Documentation Updates and Changes
GT-64240A System Controller for MIPS Processors
Datasheet Rev. A, Dated August 29, 2001

DCU-GT-64240A

This document provides changes to the *GT-64240A System Controller for MIPS Processors*, datasheet, Rev. A, dated August 29, 2001.

Figure 27: SR71000 L3 Read Hit Example

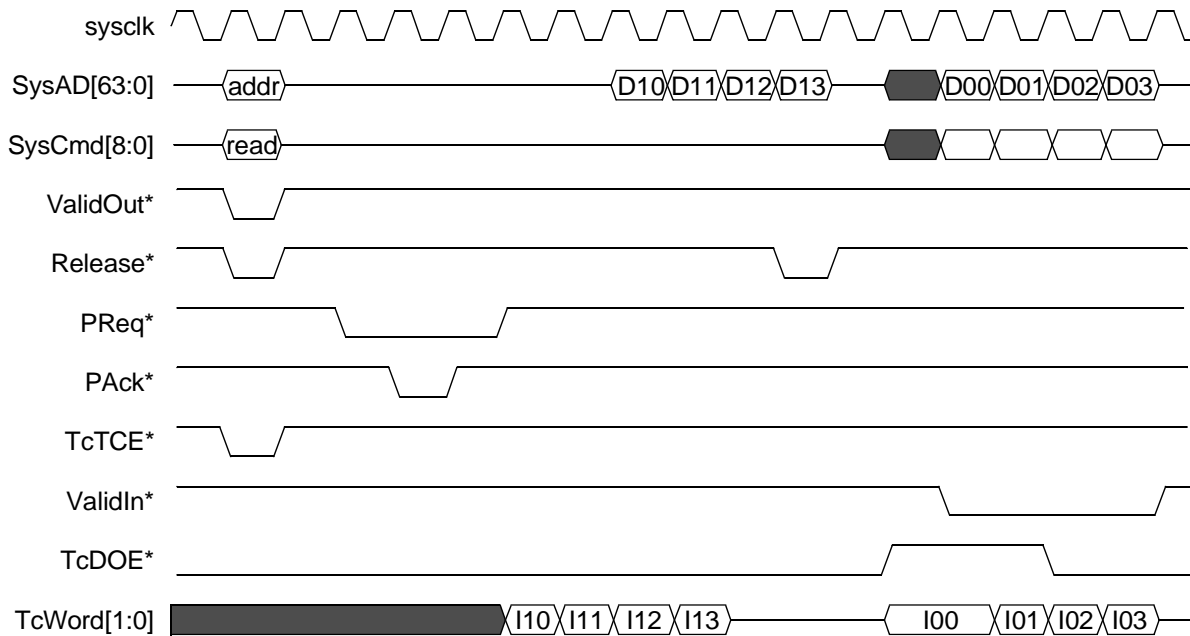
The SR71000 support the non-pedant reads, also when interfacing L3 cache. Similar to the RM7000, it can pipe two read transactions, where one of the two is cache miss and the other is cache hit, as shown in Figure 27.

Since the second read transaction is a cache hit, it is not converted to a SysAD bus transaction. Instead, the CPU accesses the data RAM directly and then simply releases the bus back to the GT-64240A (asserts Release*).
